PLAN AND PROFILE OF PROPOSED STATE HIGHWAY

PRINCE WILLIAM PARKWAY INTERCHANGE AT REALIGNED BALLS FORD ROAD

VDOT Proj.No.6234-076-266

Notice of Design Change (NDC) #02
JUNE 2021

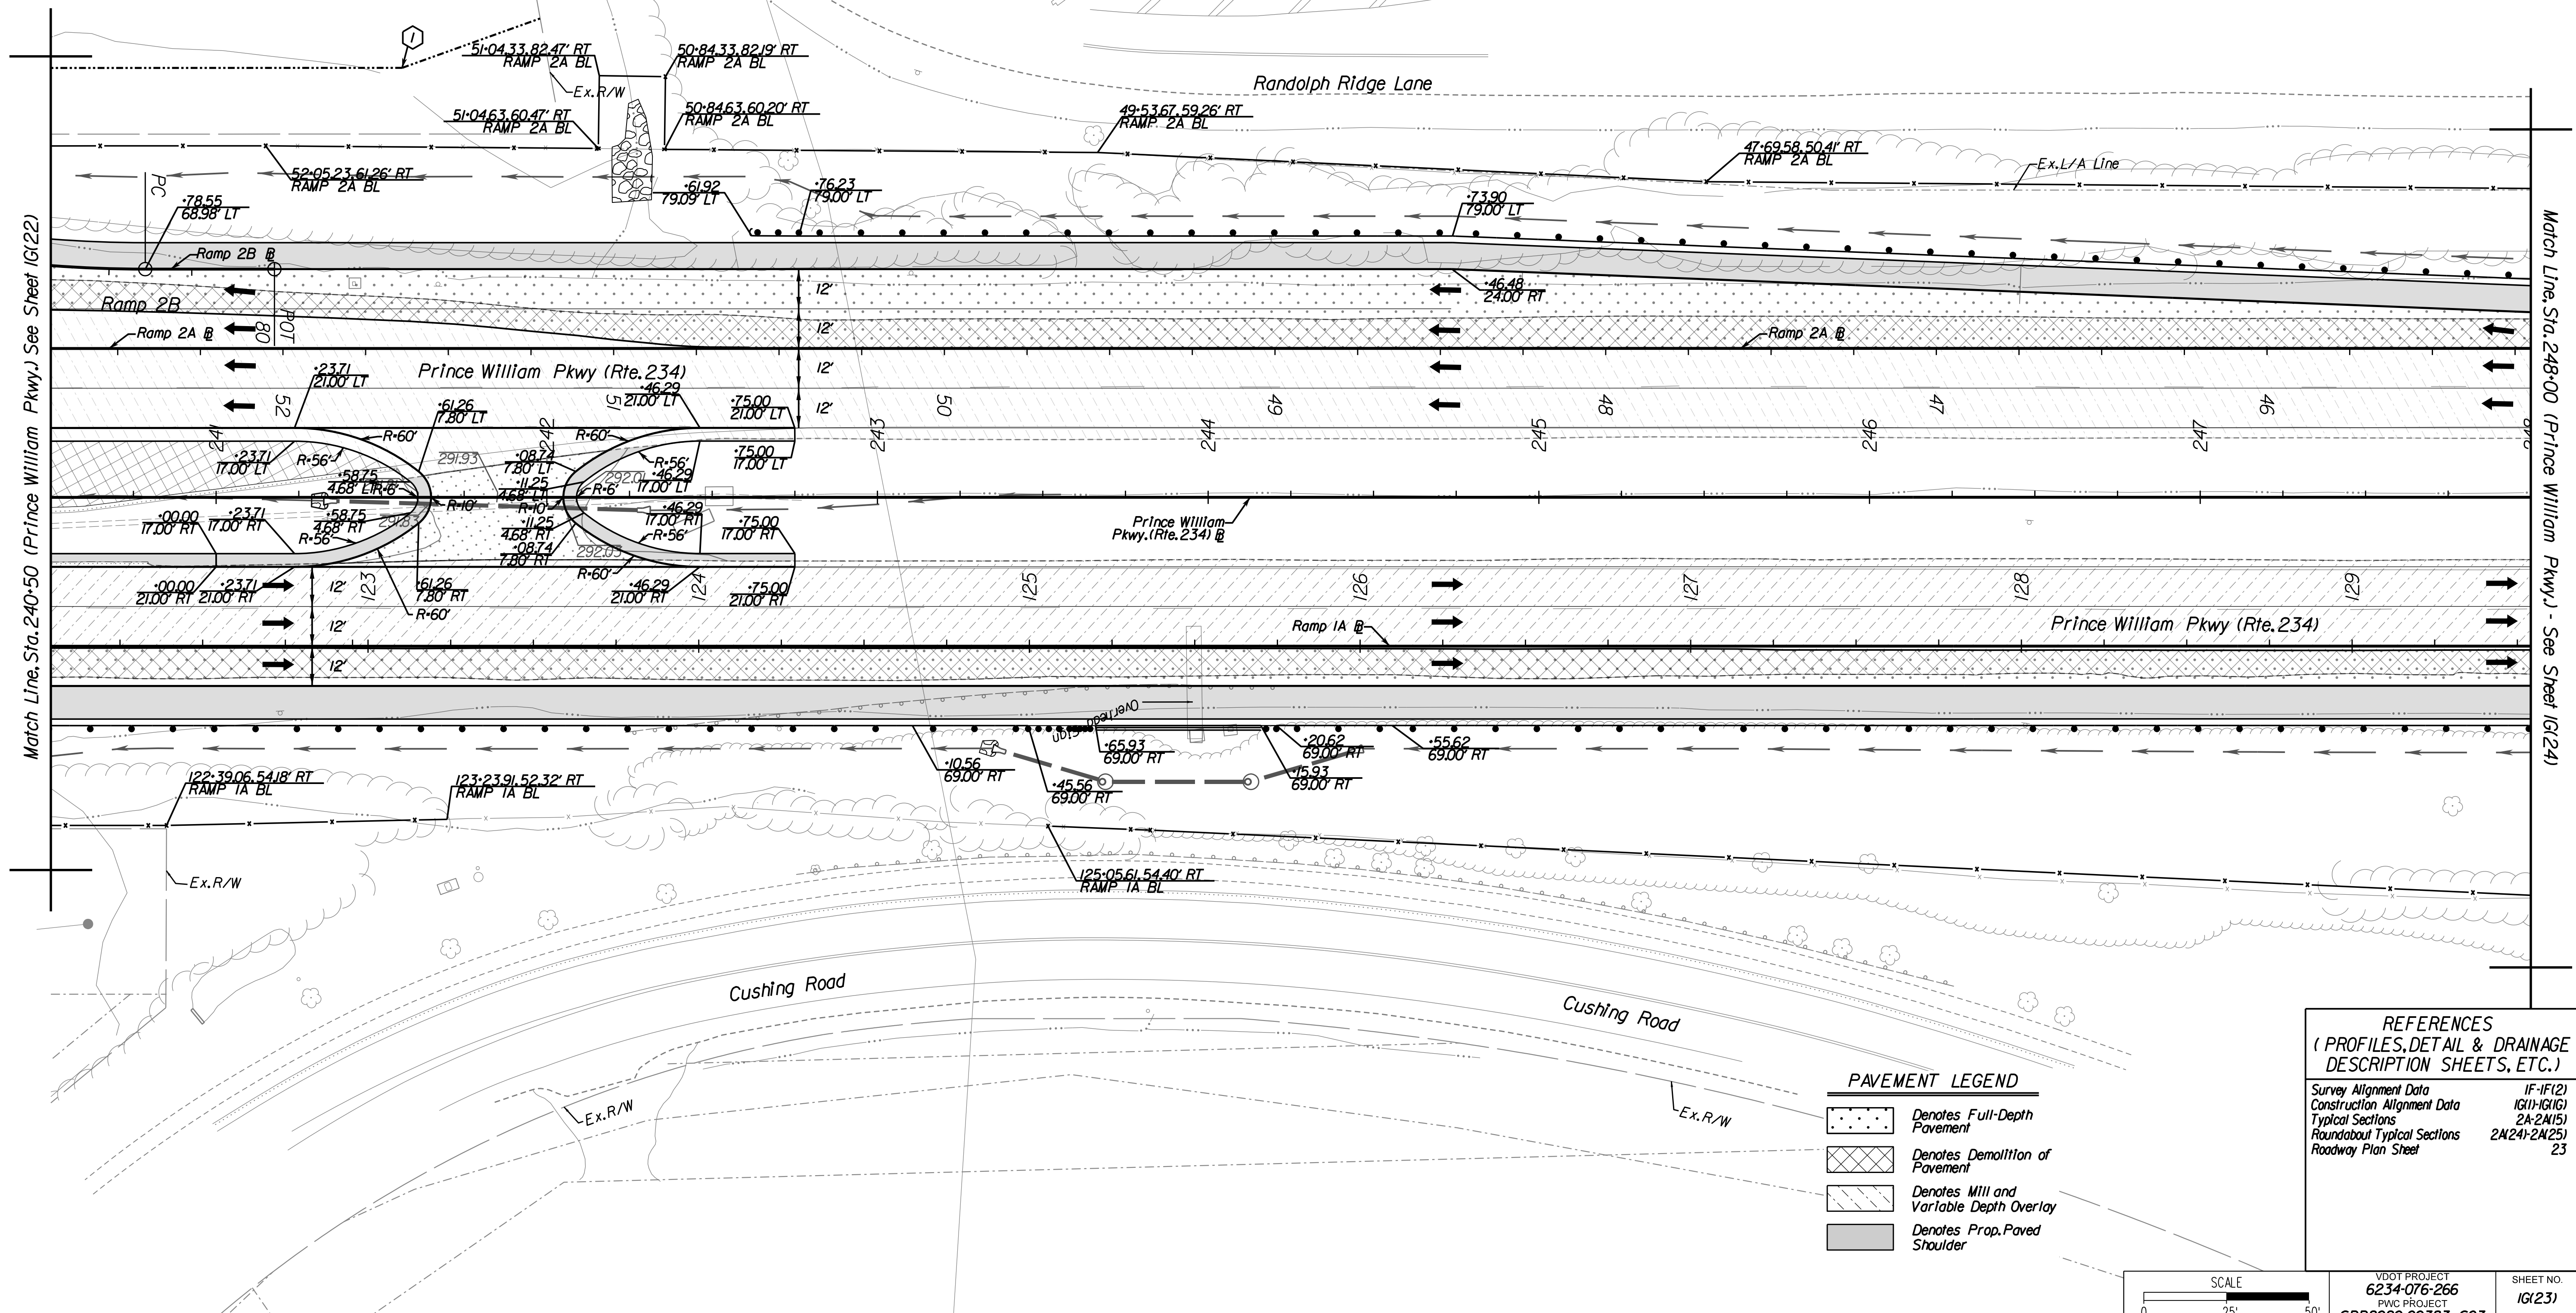
02 Revised sheet to include changes due to crossover.

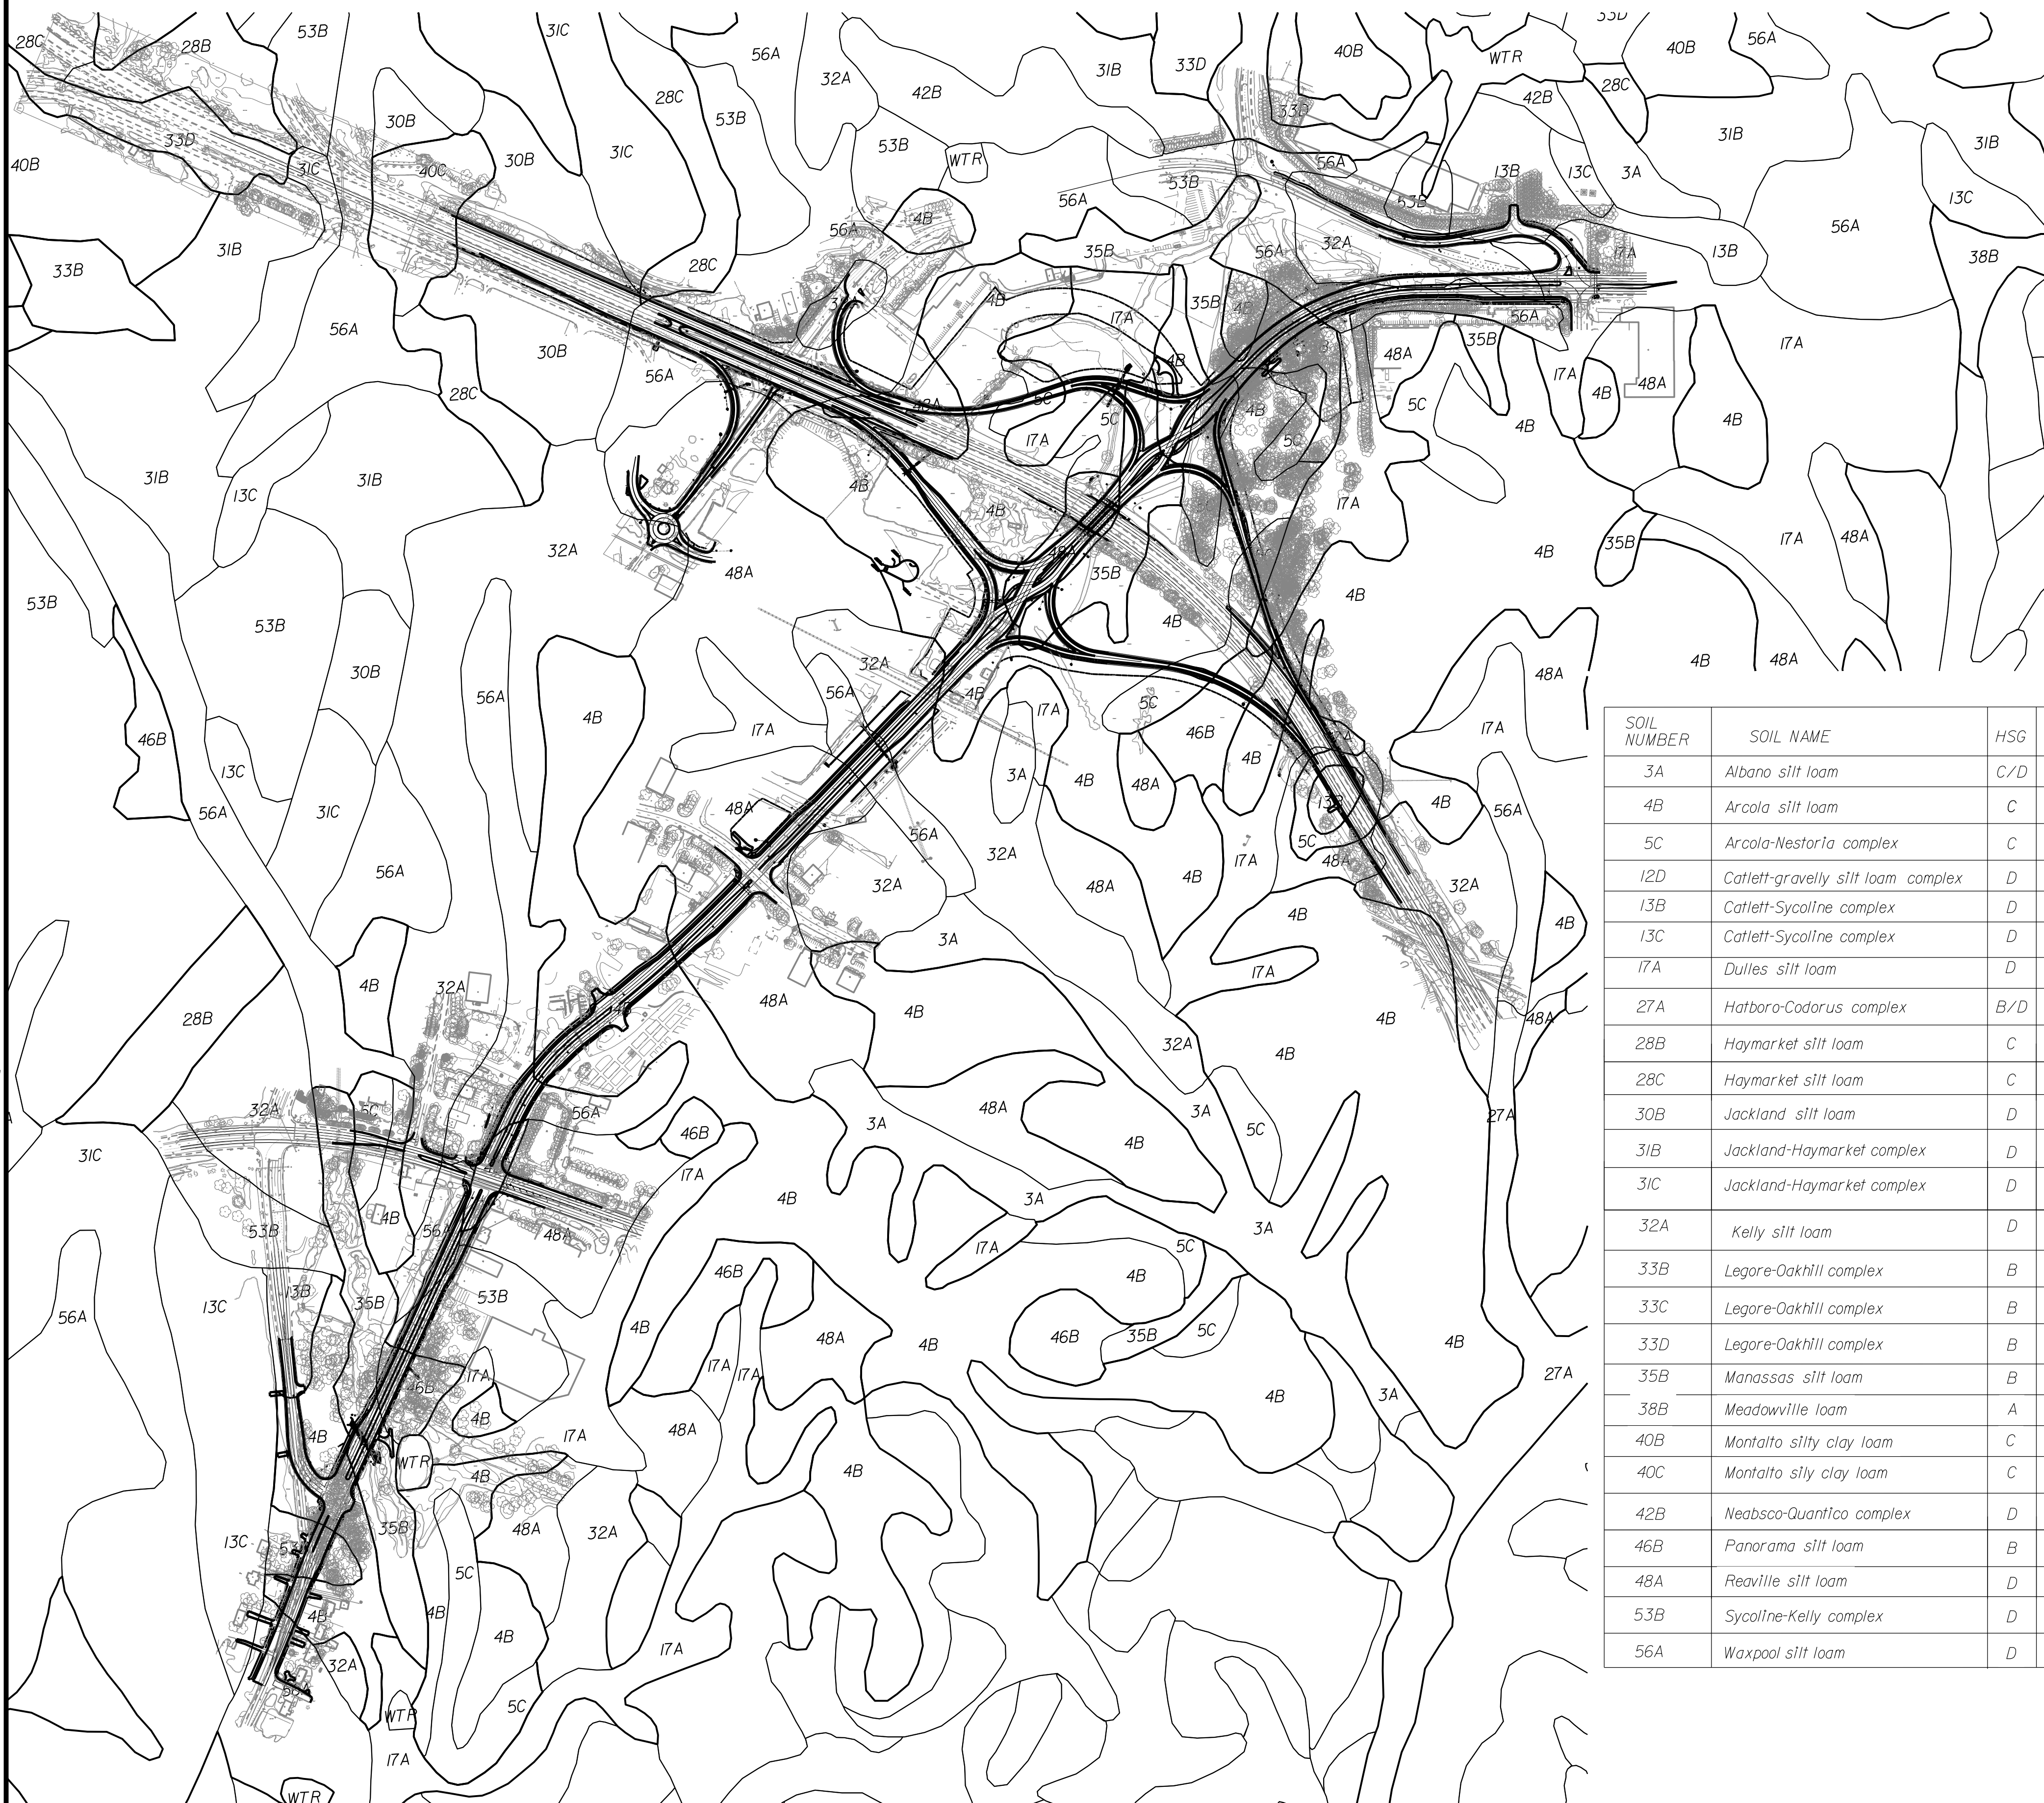
02 Revised soil map to include roundabout plan view.
